STRIPCAT II

Stripcat 2.1 Update :

Size

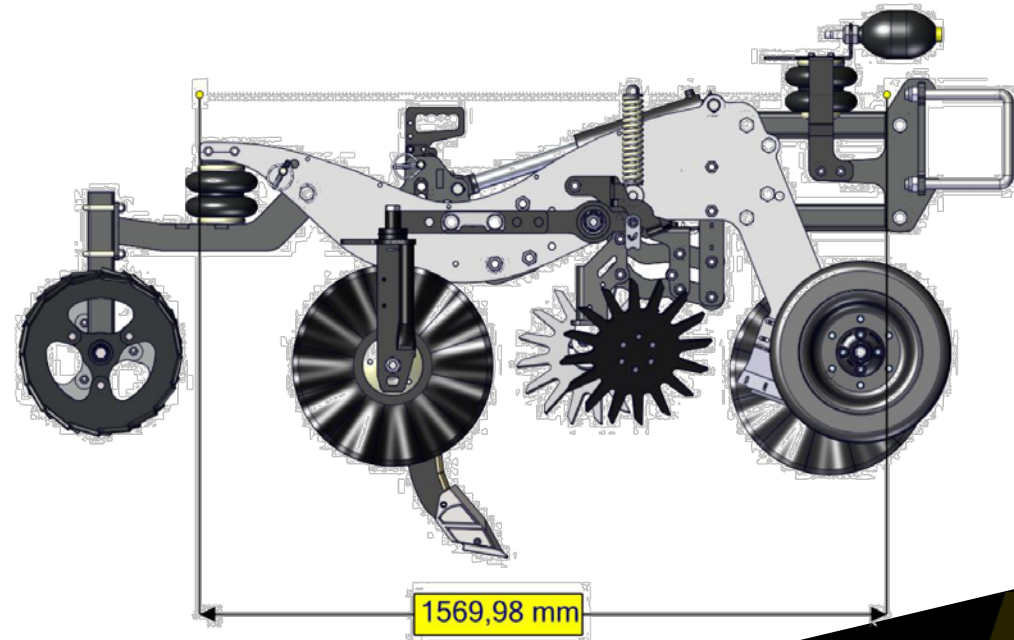
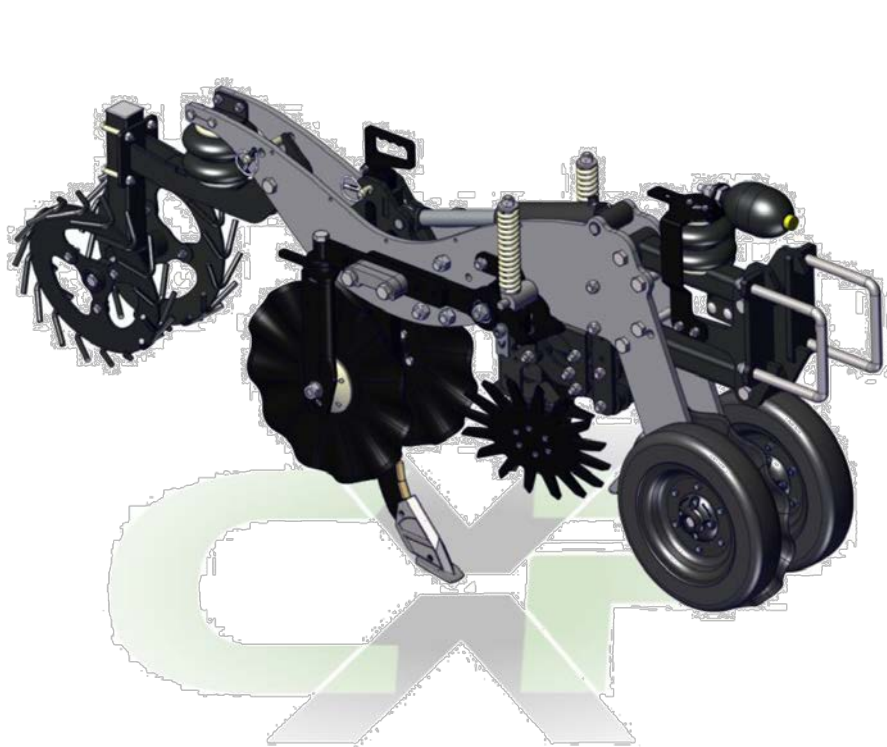
STRIPCAT 2.1 = +10cm to allow twin solid outlet, solid or twin solid + liquid or solid + liquid

Arm parallelogram

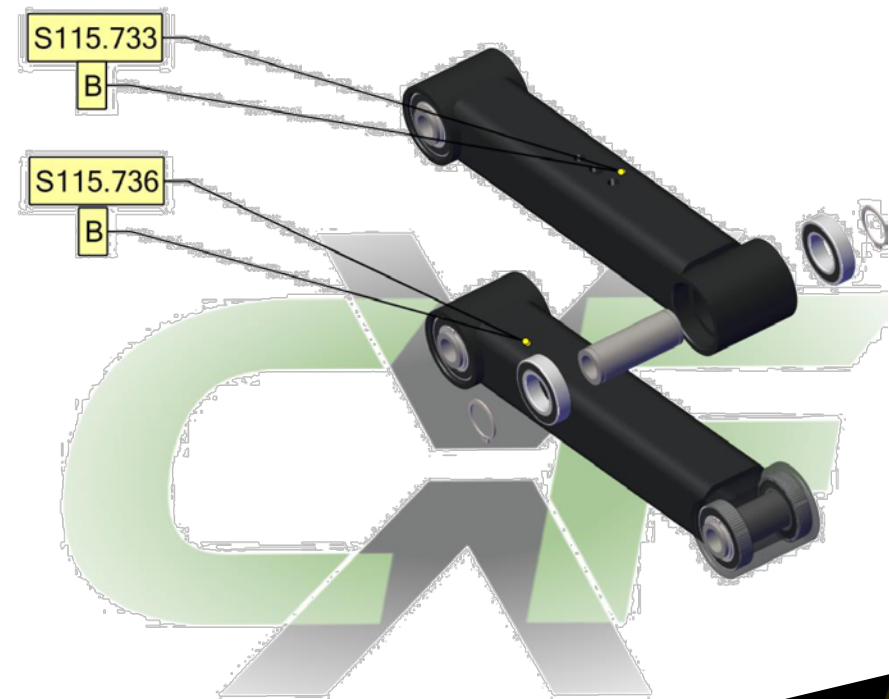
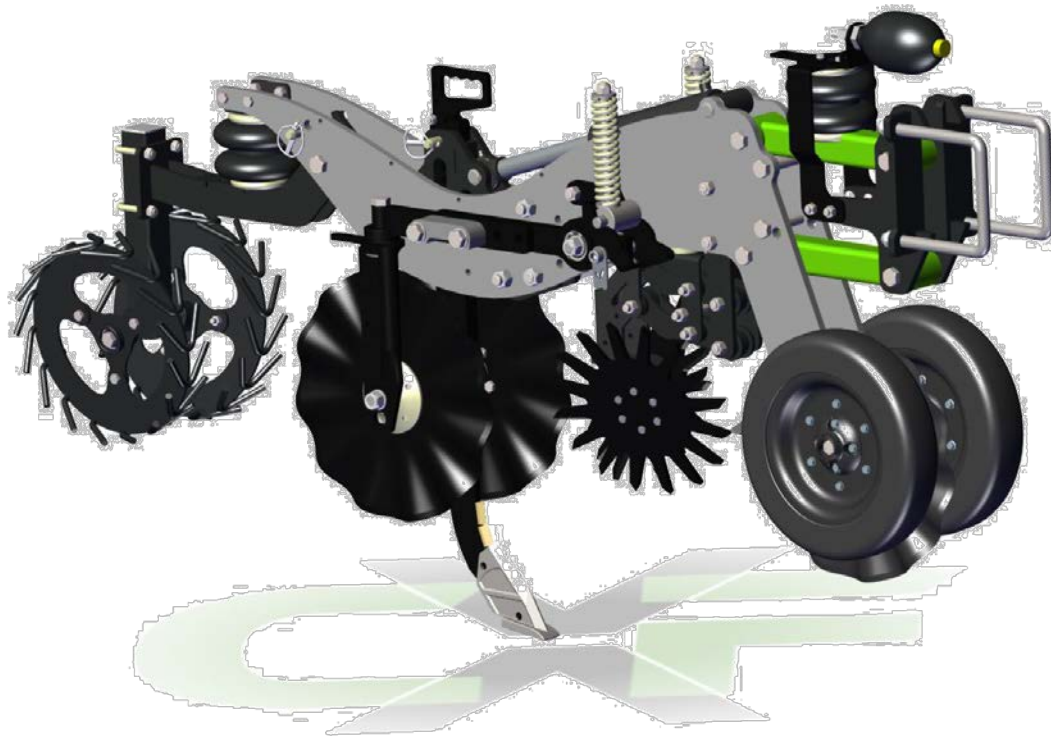
Replace bushing by bearing

Trash Wheel

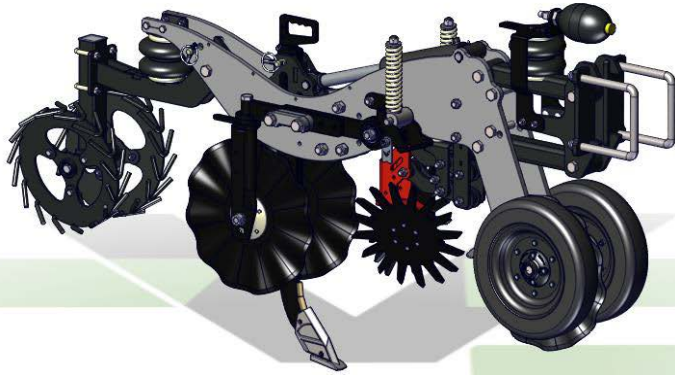
New angle (less aggressive) to easier way of residue in interrow 45cm/50cm

New trash wheel frame to get less stone blockage

New traswheel in option for 45/50cm
flat disc less angle

Tine

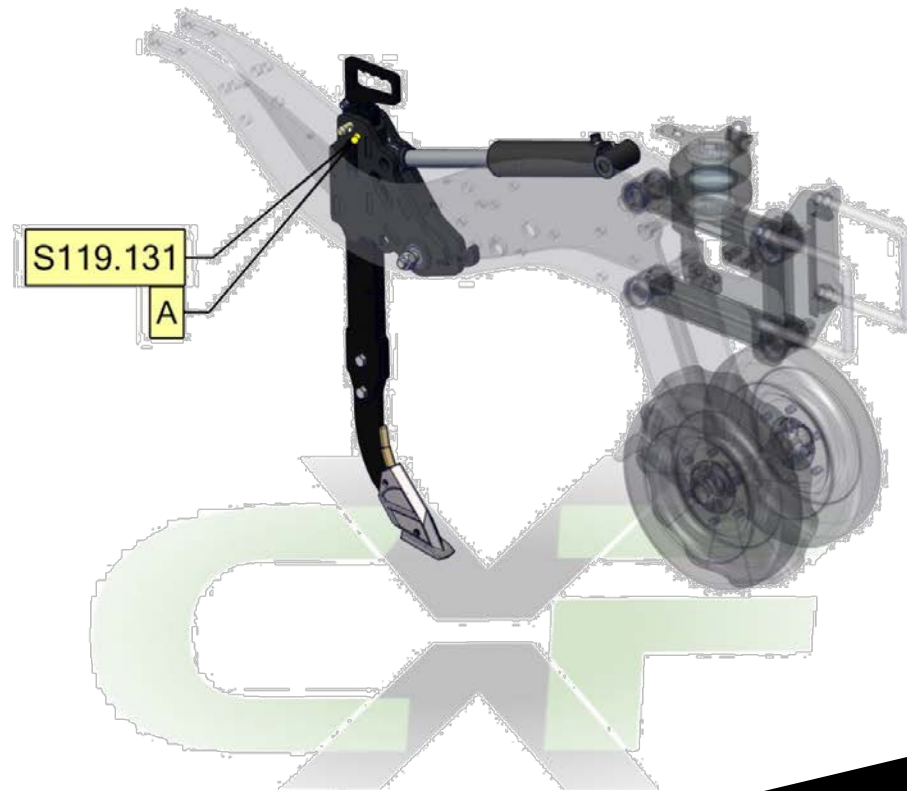
Optimisation of tine shape for shadow working depth

Disc builder

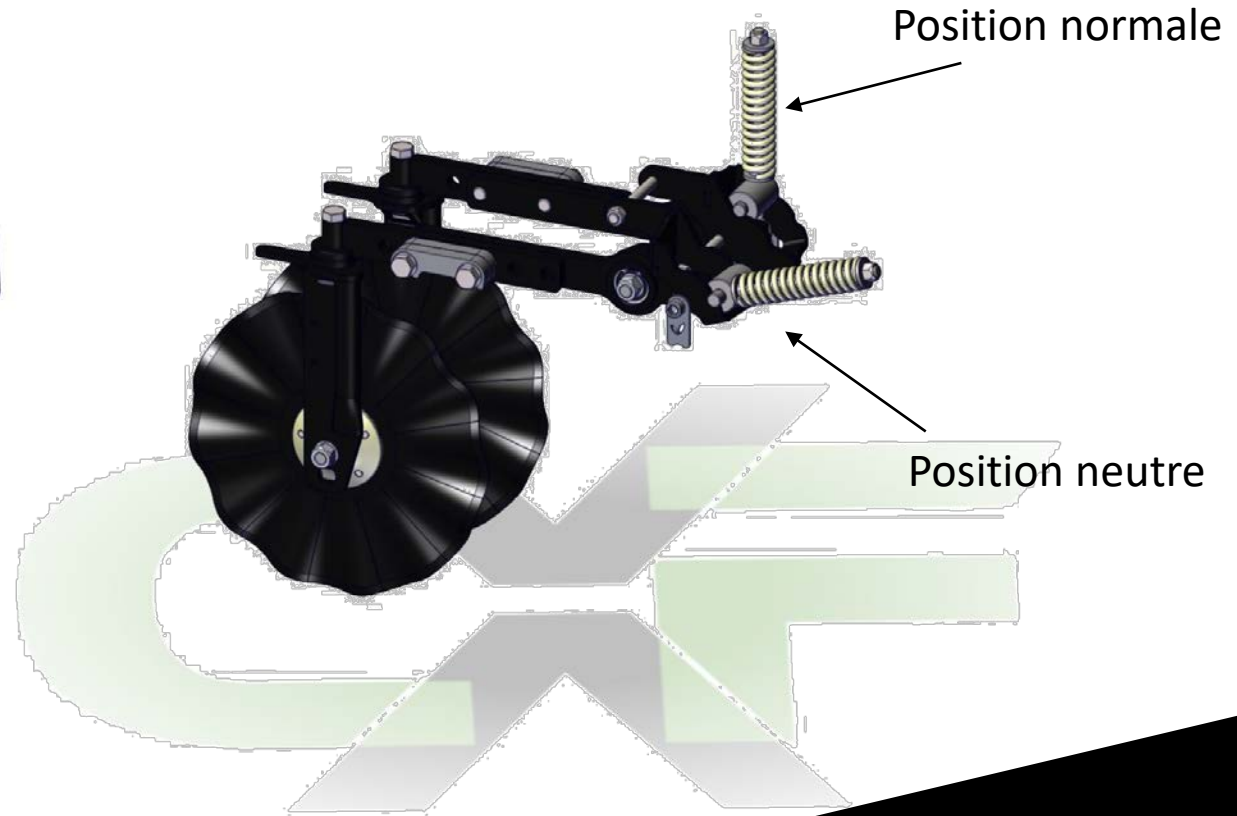
Possibility to switch of spring of disc builder in case of a lot of residue
New profile of discs for better residue flow

Closing wheel

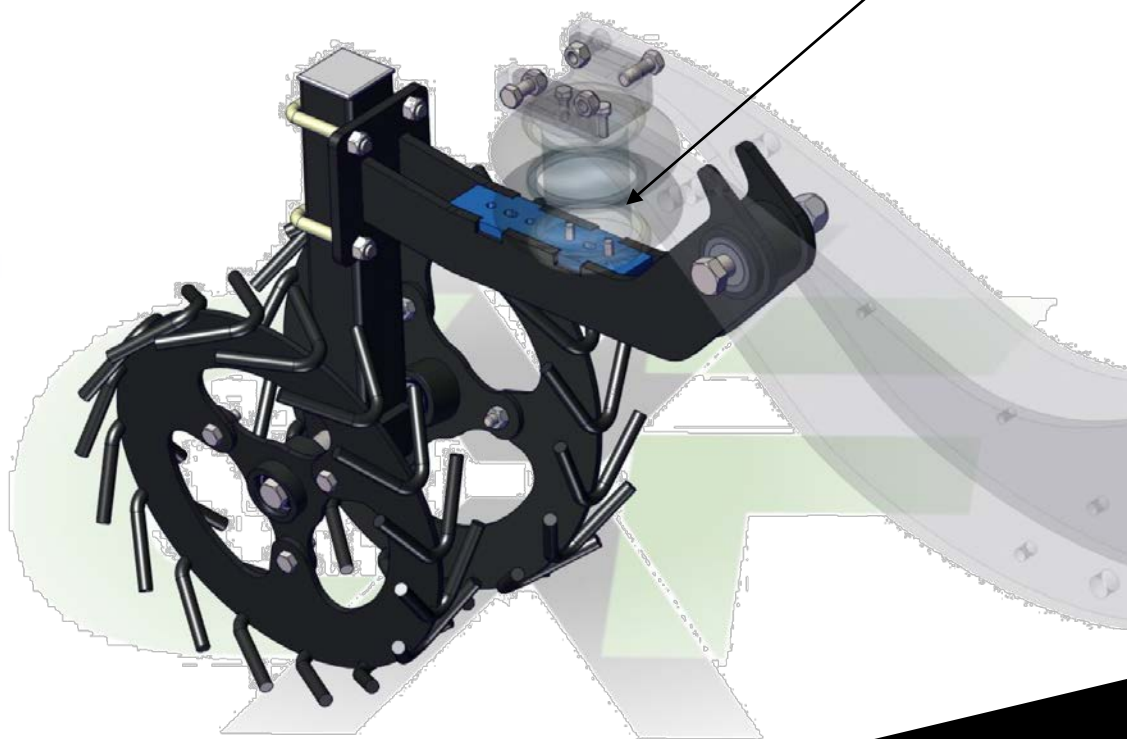
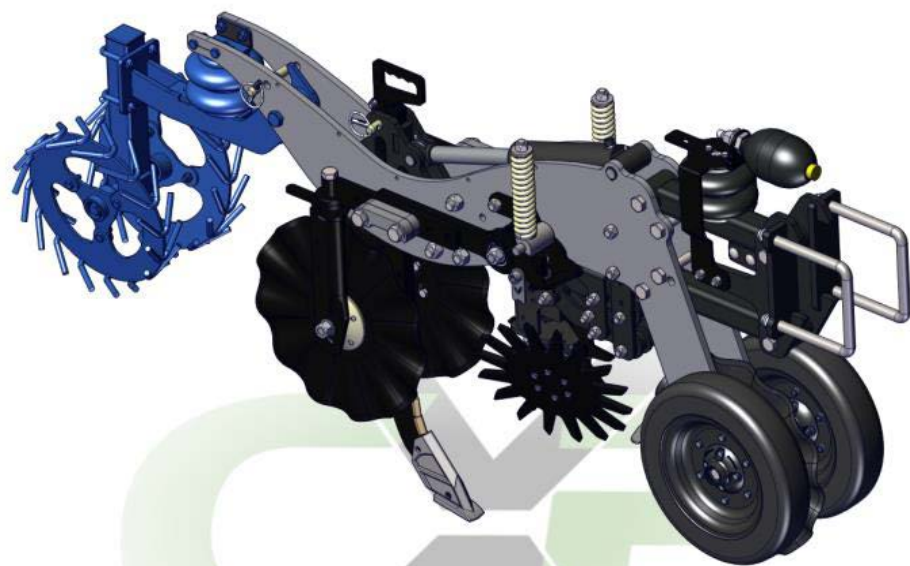
Possibility to put air poumon more on the back to increase pressure
(almost for double seeding kit)

Second position
